DEVELOPMENT NO.:	24032904
APPLICANT:	Platinum Homes (SA) Pty Ltd trading as Blag Homes
ADDRESS:	75 MARINE PDE SEACLIFF SA 5049
NATURE OF DEVELOPMENT:	Two level detached dwelling and swimming pool in rear yard
ZONING INFORMATION:	Zones: • Established Neighbourhood Overlays: • Airport Building Heights (Regulated) • Affordable Housing • Character Area • Prescribed Wells Area • Regulated and Significant Tree • Stormwater Management • Urban Tree Canopy Technical Numeric Variations (TNVs): • Minimum Frontage (Minimum frontage for a detached dwelling is 12m; semi-detached dwelling is 12m; row dwelling is 12m; group dwelling is 12m; residential flat building is 12m) • Minimum Site Area (Minimum site area for a detached dwelling is 450 sqm; semi-detached dwelling is 400 sqm; row dwelling is 350 sqm; group dwelling is 350 sqm; residential flat building is 350 sqm) • Maximum Building Height (Levels) (Maximum building height is 1 level)

Reasons for Deferral:

Amended Plans:

FRONT ELEVATION

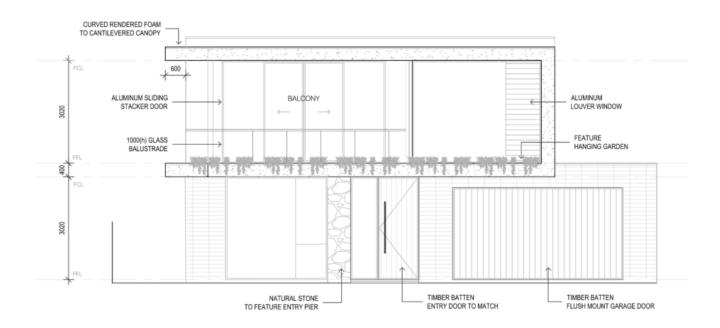
• The setback of the dwelling has been increased to 5.4 metres to the upper level and 6 metres to the ground level and garage. This is in lieu of the previous setbacks of 5.15 metres to the upper level and 5.75 metres to the ground level and garage. A Table has been provided in Attachment A, which provides a summary of front building setbacks along Marine Parade, to give context to the amended setback in comparison to the relevant street setback pattern.

Concerns relating to garage dominance has been addressed by way of altering the timber wall cladding to brickwork. The garage door remains as a timber batten appearance to match the entry door.

There has been an attempt to address solid to void ratio by way of adding aluminium louvres to the
closest street facing window, aimed at visually reducing the extent of visual glazing. The greater
void to solid ratio, particularly at the upper level, is considered to assist in reducing the visual bulk
and scale of the upper level, particularly as glazing is typically used in architecture to assist in
reducing building prominence and scale.

Regarding the dwelling setback, it is the view of planning administration that the original setback presented was sufficient and complementary to the existing and emerging street setback pattern, as sought by Zone PO 5.1. The increased primary setback is considered a positive improvement to the overall proposal. It slightly reduces the rear setback and private open space, but they are still considered to be acceptable.

Regarding the changes made to the garage by way of altering the timber panelling to brickwork, again, the original design was supported by planning administration. The materials associated with the garaging and what contributes to garage dominance is a subjective viewpoint. From the position of planning administration, the original timber cladding appeared visually to blend in with the extensive front landscaping. The timber (natural material), achieved a visual blend with the landscaping (natural elements), resulting in the dwelling component (with stonework and render) presenting visually as more prominent. Notwithstanding, the use of brickwork is satisfactory with respect to addressing the Panel's concerns and PO 10.1.

Regarding the introduction of aluminium louvres to address the solid to void ratio concerns, planning administration was supportive of the original glazed concept, particularly upstairs, as the use of glazing is typically used in architecture to soften visual bulk and scale. Notwithstanding, the introduction of the aluminium louvres is considered to achieve a good balance in addressing the solid to void ratio concern. The remaining glazing ensures the visual bulk and scale is sufficiently reduced overall.
